<i>Project Name:</i>	Rivergate Subdivision
<i>Proponent/Owner:</i>	Ben Steele / Rivergate LLC
<i>Project Address:</i>	Approximately 1900 West 600 South
<i>Request:</i>	109 Lot Subdivision
<i>Current Zoning:</i>	NR-6
<i>Date of Hearing:</i>	Dec 15 th 2022
<i>Type of Action:</i>	Quasi-Judicial
<i>Submitted By:</i>	Russ Holley, Senior Planner

Staff recommends that the Planning Commission **approve** a Subdivision Permit for project PC 22-066 Rivergate Subdivision, located on approximately 30.54 acres at approximately 1900 West 600 South; TIN #02-076-0002; -0008.

Rivergate Preliminary Plat Application
November 3, 2022

RIVERGATE SUBDIVISION
PRELIMINARY PLAT

STORMWATER CALCULATIONS

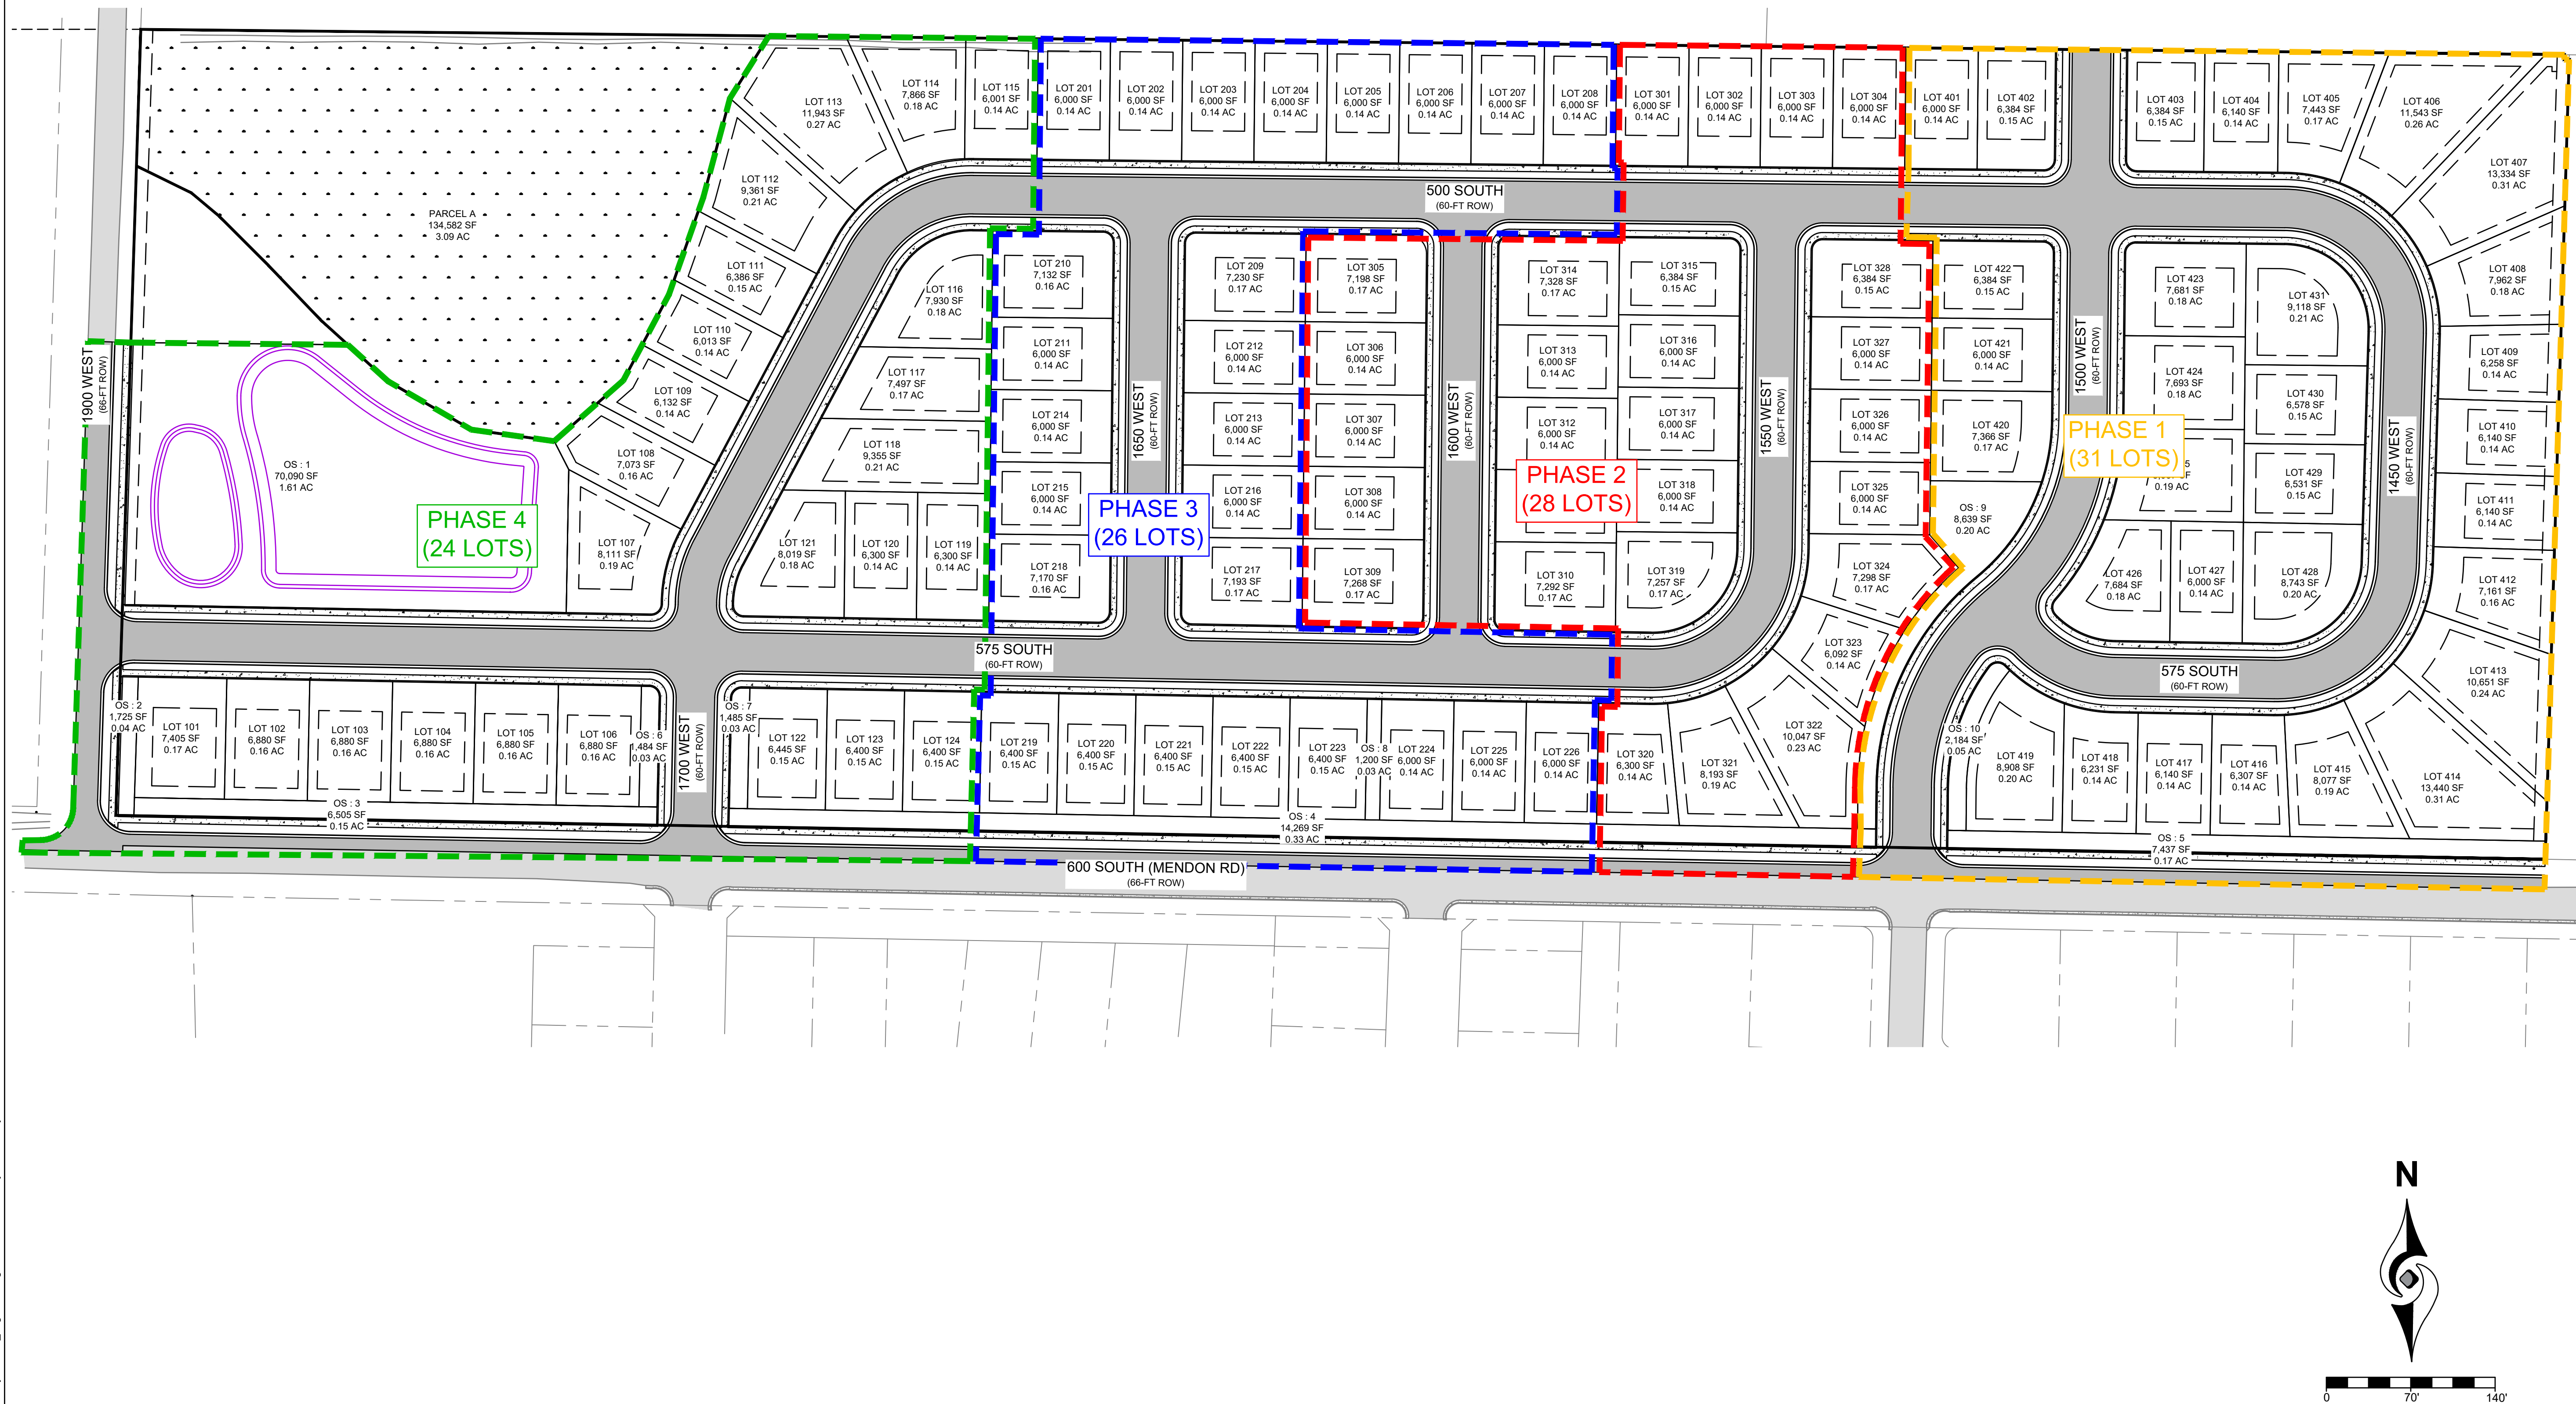
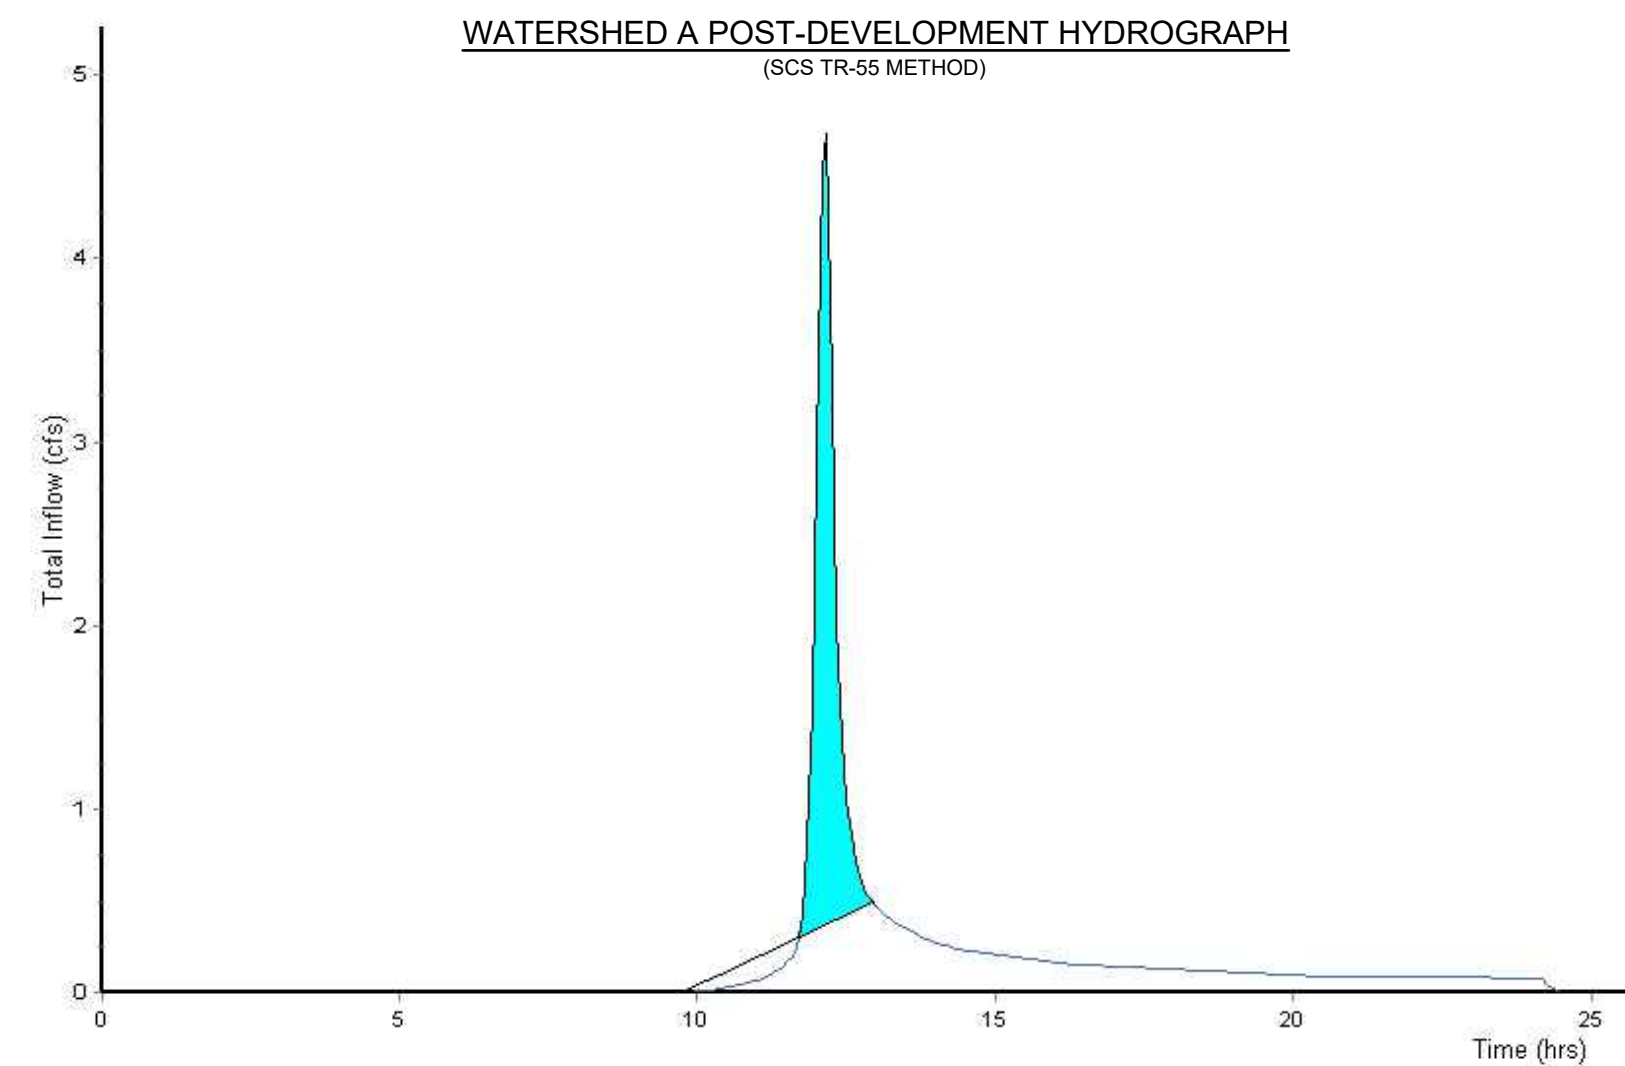
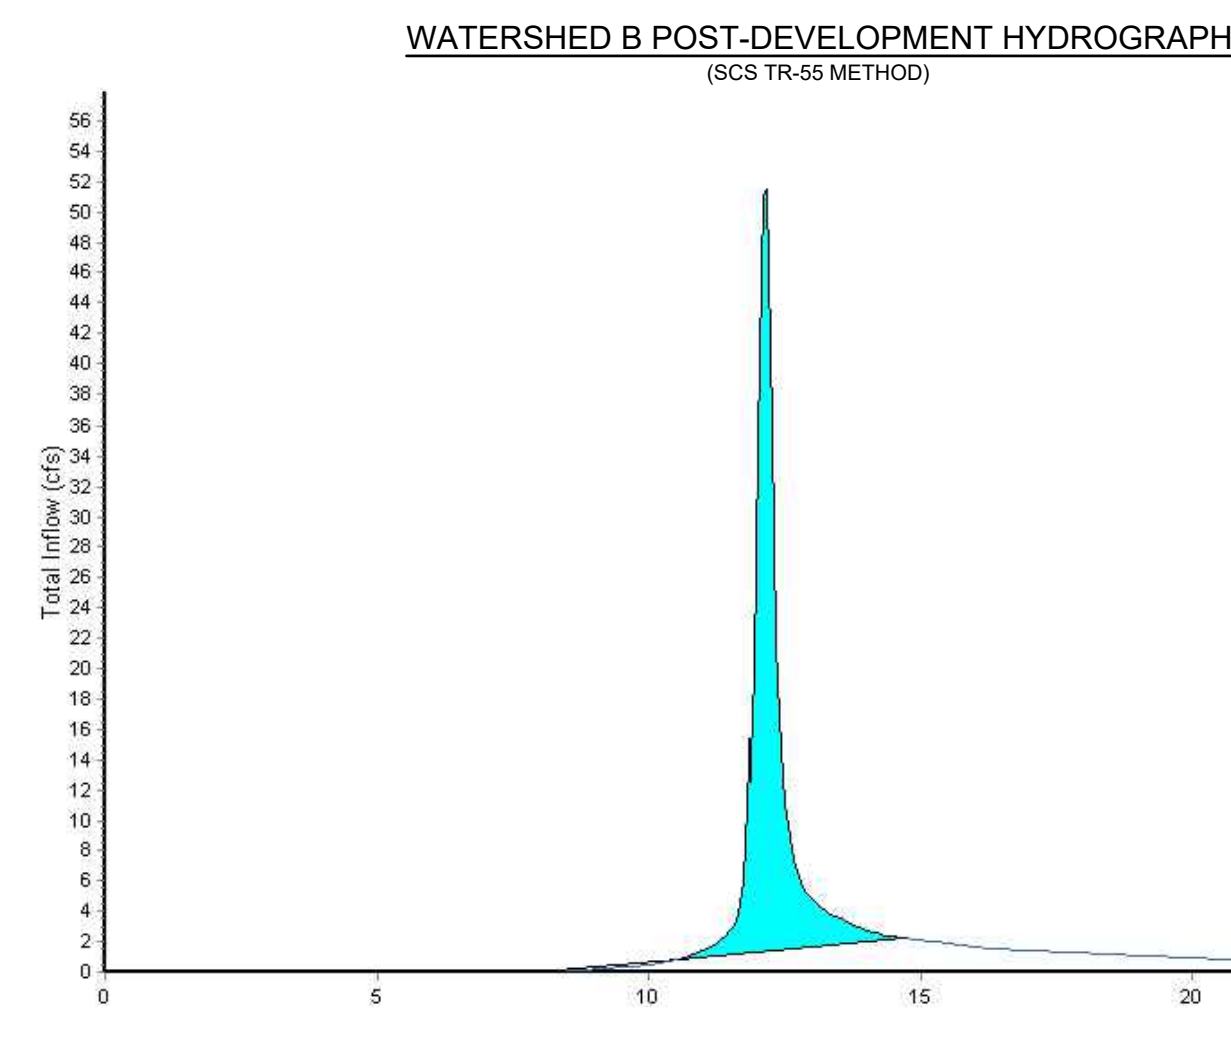
15. Provide storm water detention/retention per Logan City Design standards. This includes the retention of adjacent half street offsite where an existing management system is not established and onsite stormwater. Retention of the 90% storm event is required and shall be provided through the use of Low Impact design methods.

19. Sufficient information has not been provided to confirm the size requirements of the storm water detention/retention basins. Additional common / open space area may be required to comply with the City's storm water management standards.
